SKYLINE COLLEGE

STUDENT SUPPORT & COMMUNITY SERVICES CENTER AND SCIENCE ANNEX BUILDING

DSA INCREMENT ONE SUBMITTAL

OCTOBER 21, 2004 PROJECT RECORD DOCUMENTS

6 SECTION @ LOADING DOCK
SCALE: 3/4" = 1'-0"

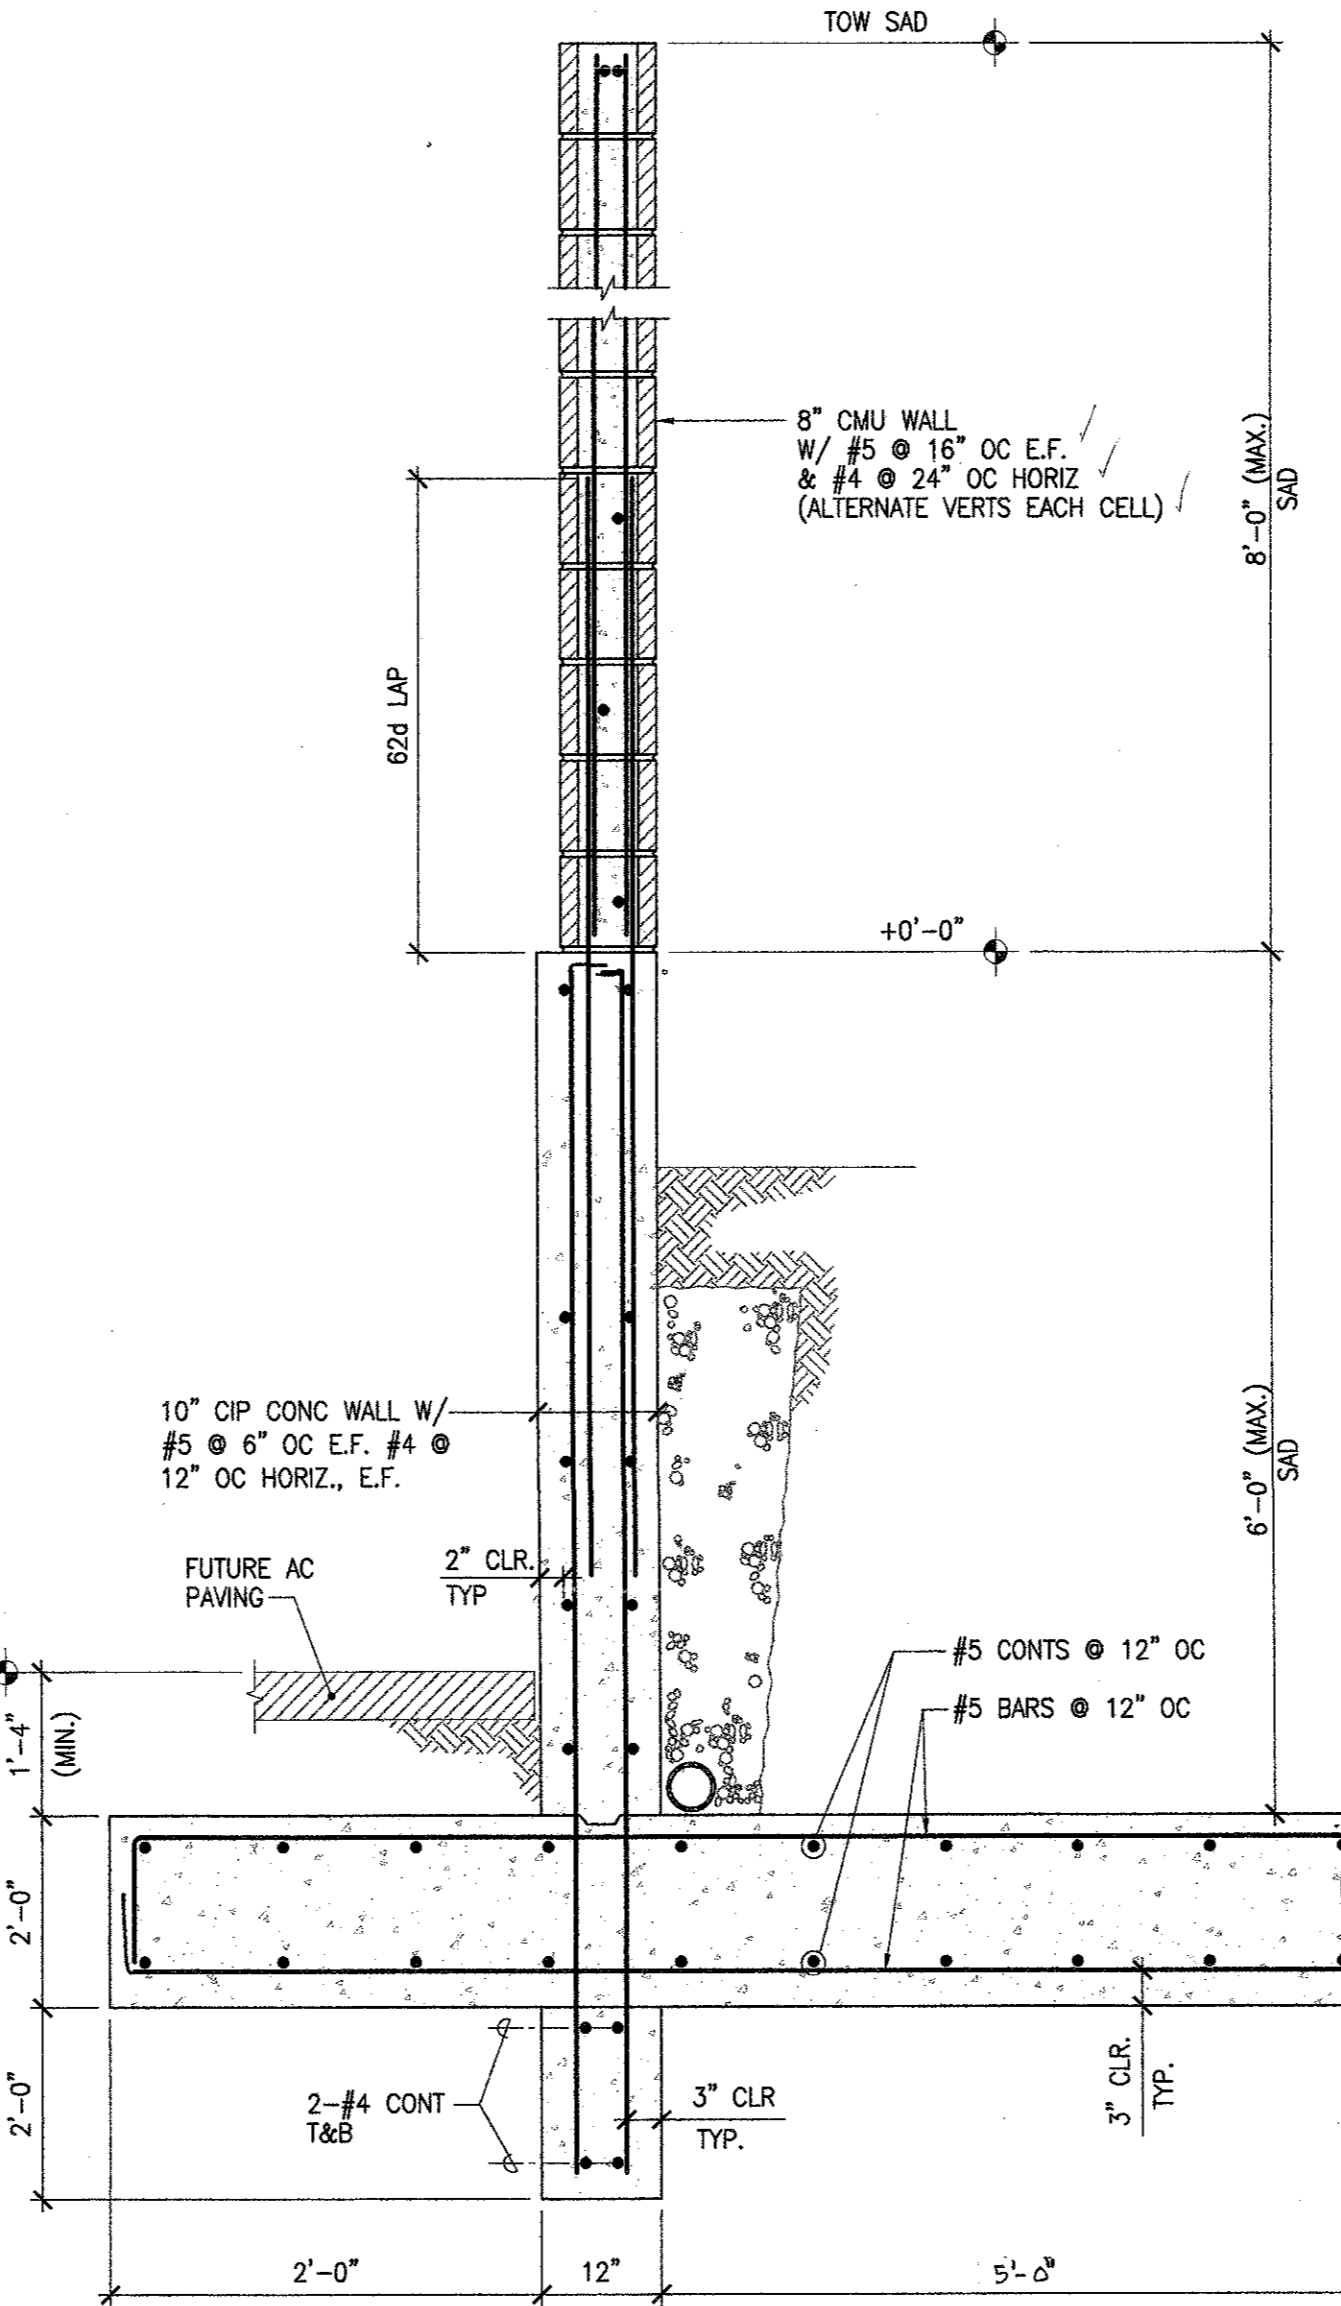
Question: 12-17-05 LK

Please Reference Increment 1 Drawing S8.3.2, and Increment 2 DSA Stamped Drawing AA2.01 thru AA2.31

On Detail 6 of S8.3.2 there are structural steel members shown to provide a walk way from Science Annex Building 7A to Existing Building 7. There is also a noted that states: 3'-0" (max.) SAD.

Referencing the architectural drawing the only information provided is that the passage way is to be 6'-6" wide as stated on AA2.01 and AA2.02.

8 ELEVATION AT LINE E
 SCALE: 3/16"=1'-0"

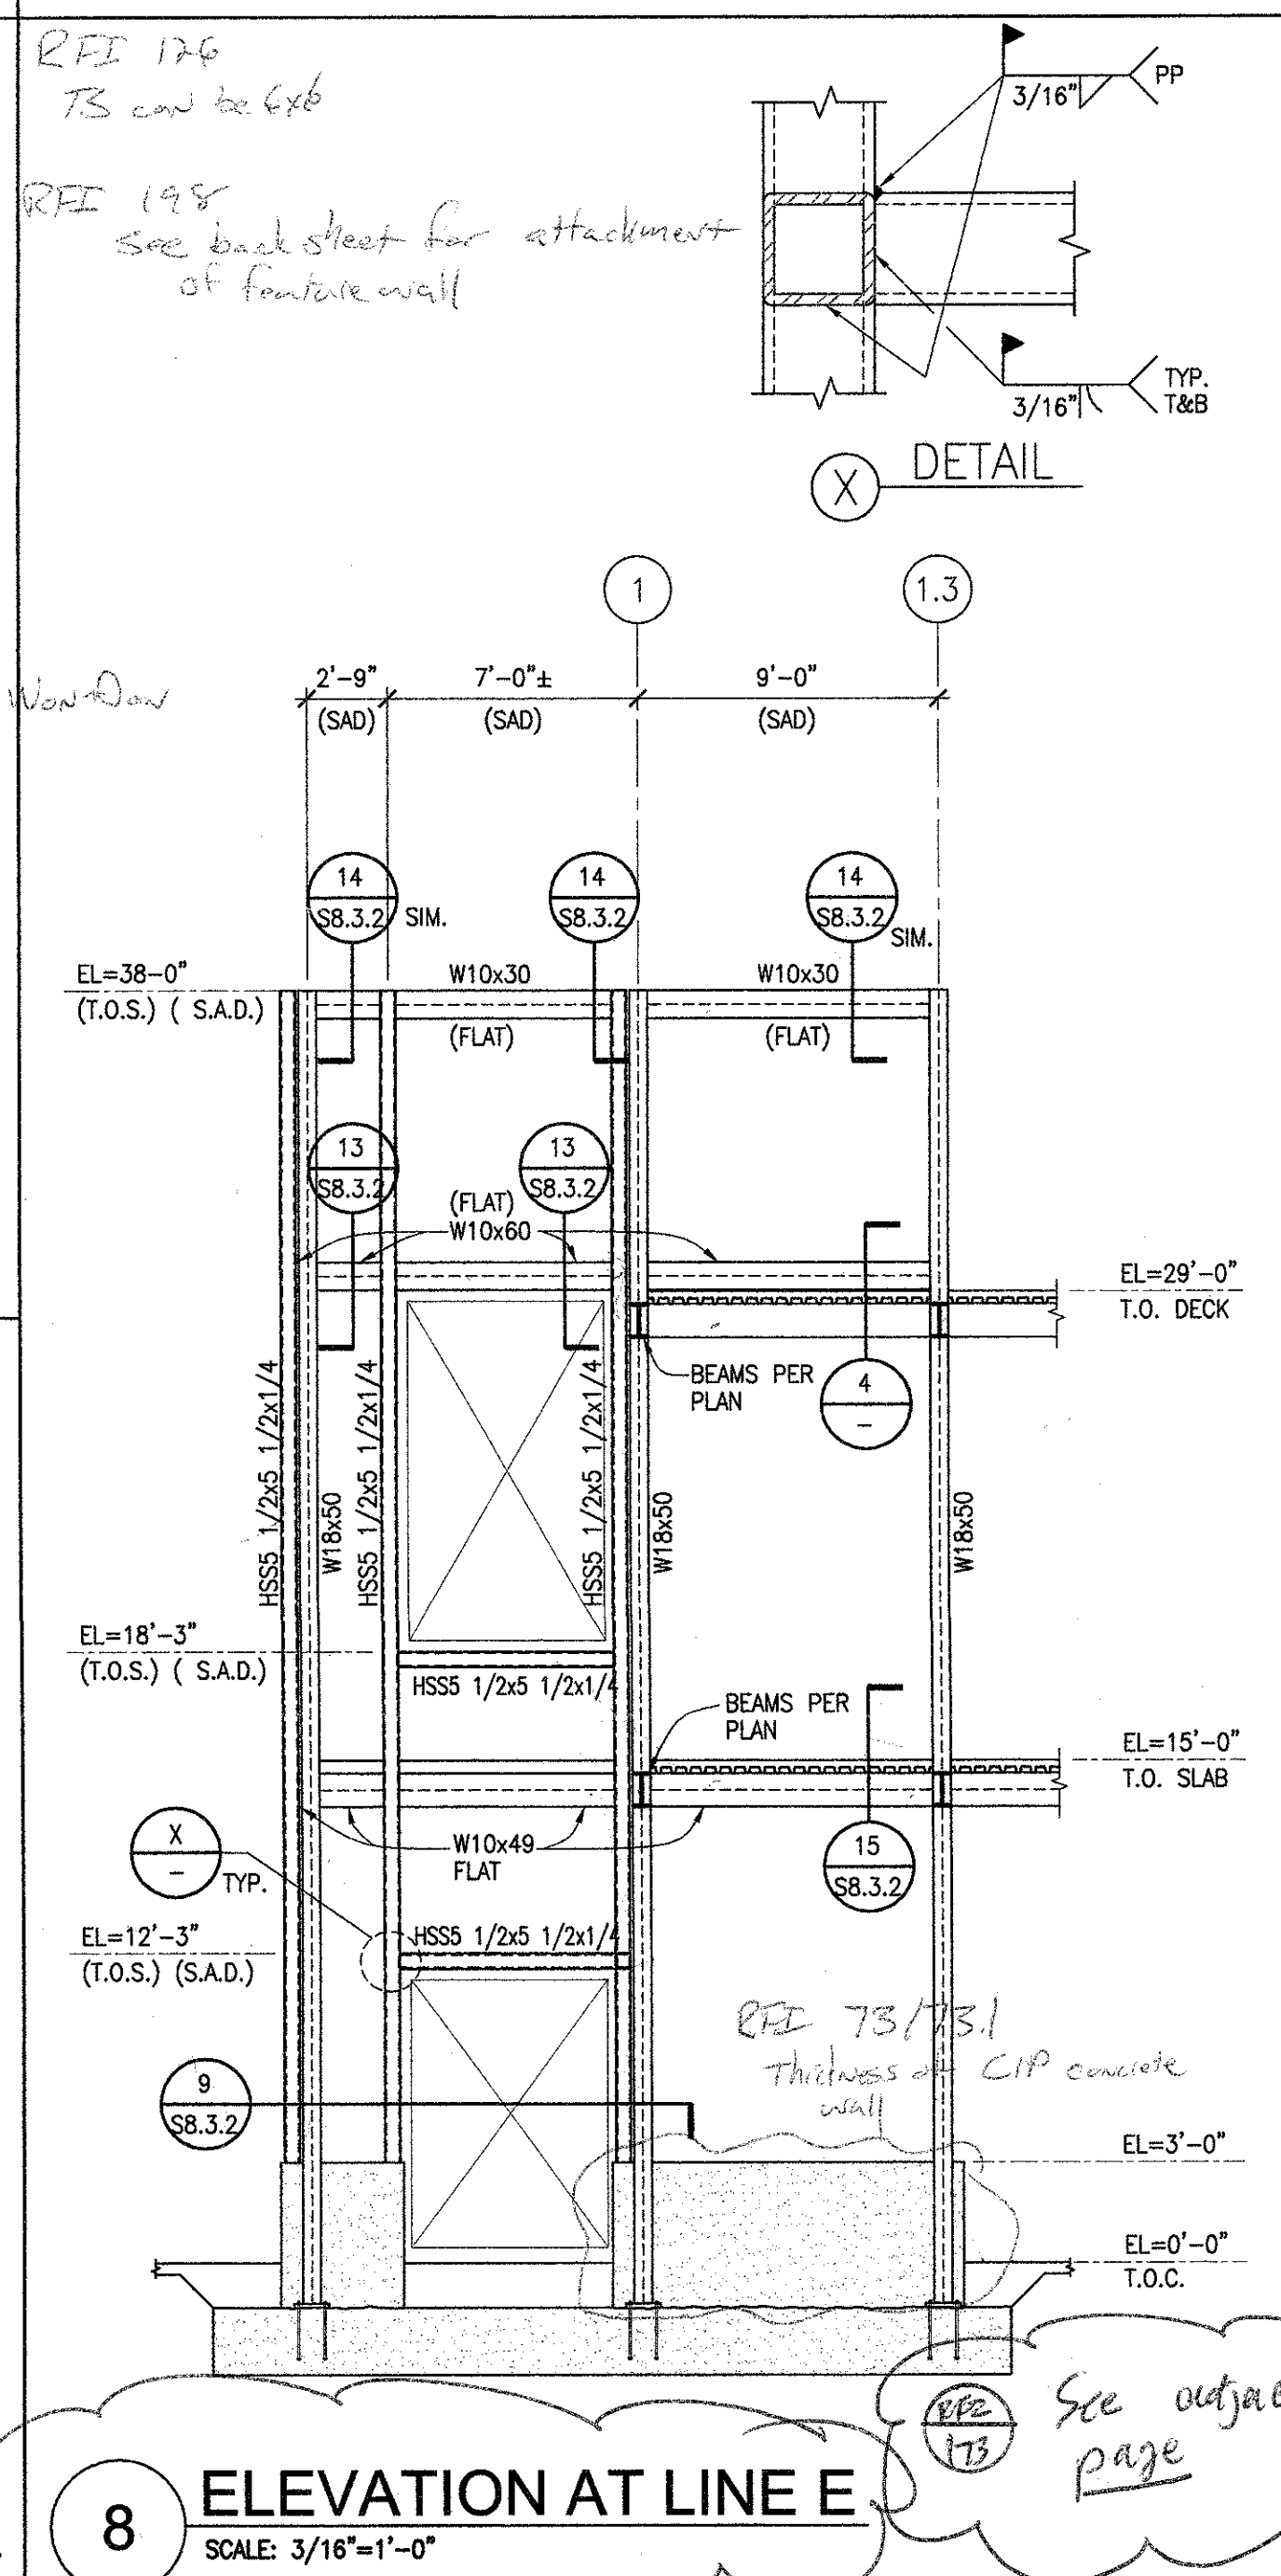
Question
 Reference Increment No. 1 drawings sheet SB2.02 and SB2.03 as well as sheets SB.3.1 detail 8 and SB.3.2 details 14 and 13.
 Also reference attached sketch.

Consultant Comments
 If this alignment issue is occurring in the 7ft or 9ft long segments as shown in det 8/SB.3.1, then it would be acceptable to align the beam skewed (max. 3/8" as shown in your sketch) to provide CPW. Confirm with Architects and coordinate as necessary that this does not affect metal-stud framing. If the 3/8" skew occurs in 2' segment on detail 8/SB.3.1 then relocate the 1/2" thick plates at column web to their designed locations per 13/SB.3.2 and/or 14/SB.3.2 ... Tejas, Crosby Group
